February 18, 2019
BOARD OF COUNTY COMMISSIONERS
ORANGE COUNTY, FLORIDA
Addendum No. 1, IFB Y19-723-RC
KELLY PARK RESTROOM

Bid Opening Date: February 26, 2019

Mounting height for the SIGNAGE (FBC Accessibility Section 703.4.1)

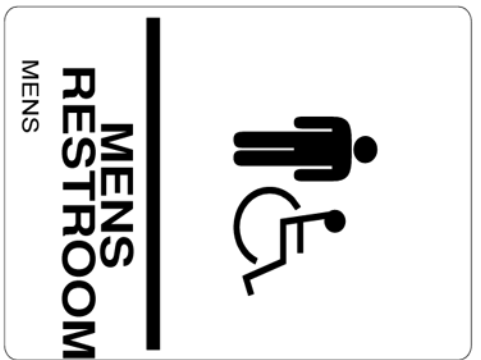
Signs are to be mounted at a height to allow the baselines of raised characters to be located between 48" and 60" above the ground.

Minimum Height: Baseline of lowest character mounted no lower than 48" above floor
Maximum Height: Baseline of highest character mounted no higher than 60" above floor
